# Notice of Decision

## Conditional Use Review

CU-05-18

Review Body:	Staff (Type I-L review)
Type of Application:	Conditional Use Review to Renovate the West Albany High School: 101,900 square foot addition for a new performing arts center, administration and education wing. A new bus drop-off and parent drop-off will be added with modified parking lots along Elm, Queen and Liberty, and the existing tennis courts will be relocated to the south of the property. Through this conditional use review, a request for a waiver to the 30-foot building height limit is included per ADC 3.340(2) to allow the proposed gymnasium addition to be 34 feet in height, and the performing arts center to be 54 feet in height.
Property Owner / Applicant:	Russ Allen, Greater Albany Public School District, 718 Seventh Avenue SW, Albany, OR 97321
Architect / Representative:	Amy Vohs, DLR Group, 421 SW Sixth Ave, Suite 1212, Portland, OR 97204
Address/Location	1130 Queen Avenue SW

ARCHITECTURAL SITE PLAN  
WEST ALBANY HIGH SCHOOL  
GREATER ALBANY SCHOOL DISTRICT

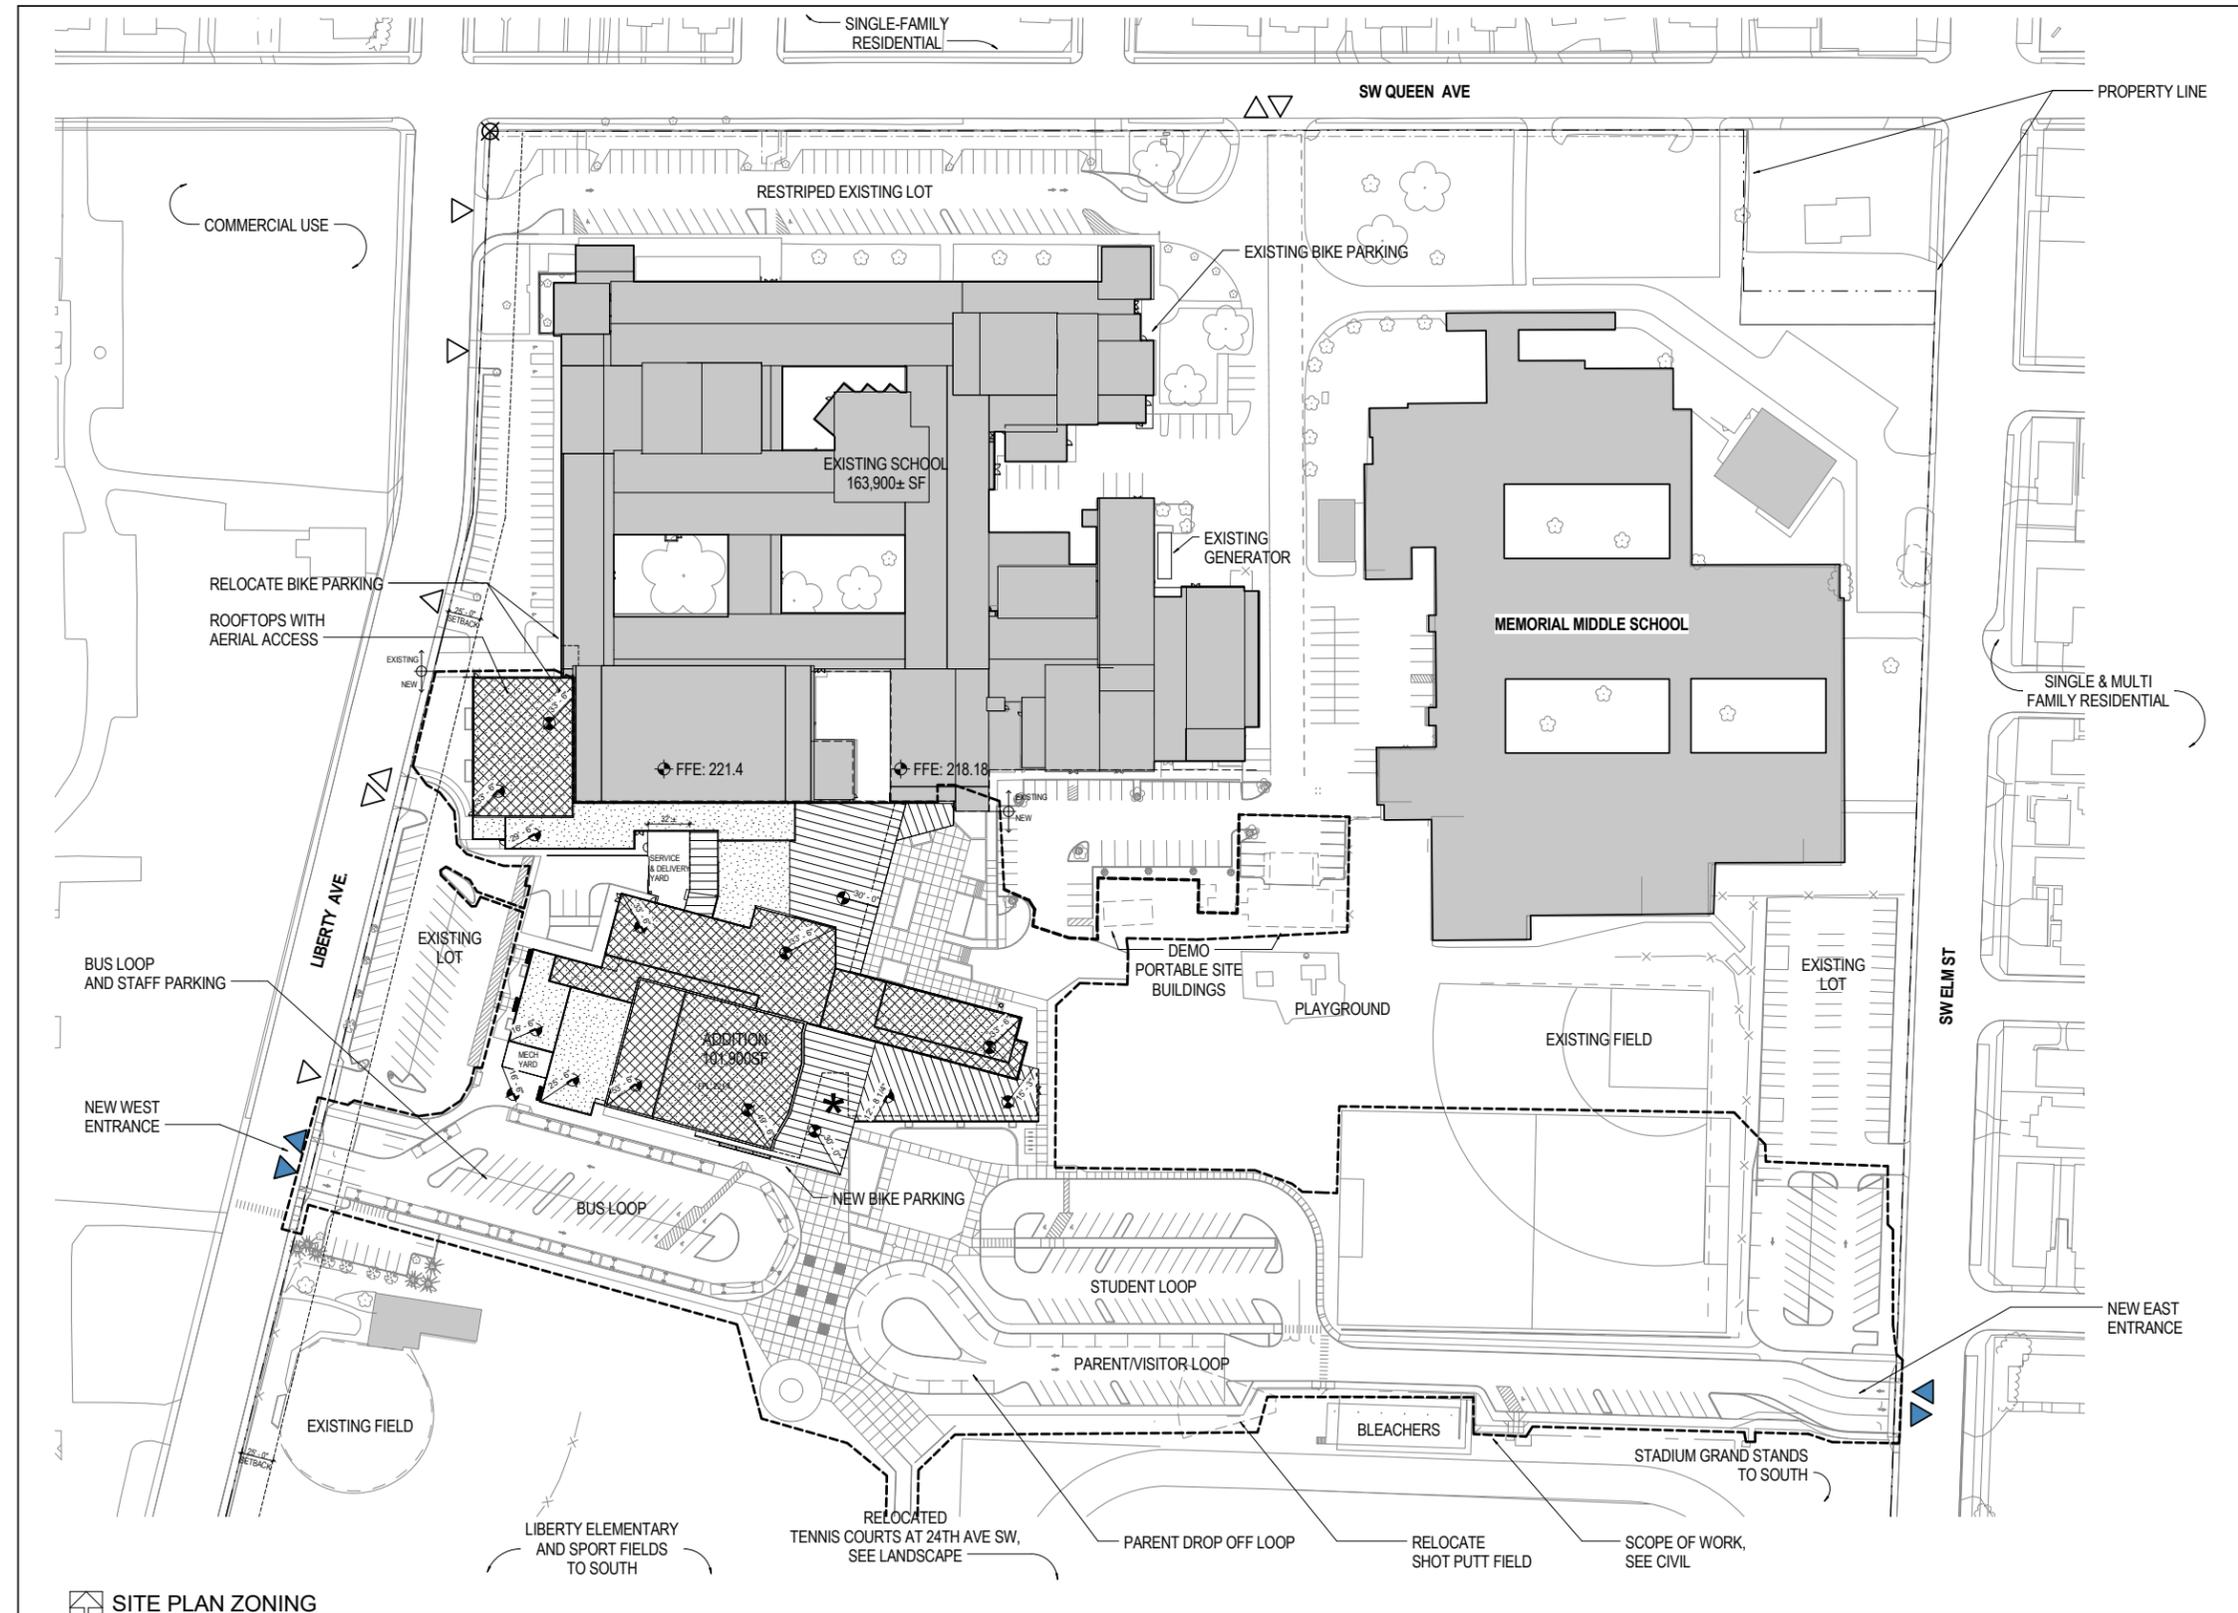
- Condition 1 Prior to issuance of a building permit, a final site plan shall be submitted for review and approval by the Community Development Department to ensure that all new school building and recreational facilities (i.e. tennis courts) are setback at least 25 feet from the front property lines in accordance with ADC 3.330.

- Condition 6 Prior to issuance of an occupancy permit, the applicant shall construct a new driveway to Liberty Street and a new driveway to Elm Street at the locations shown on the approved site plan.
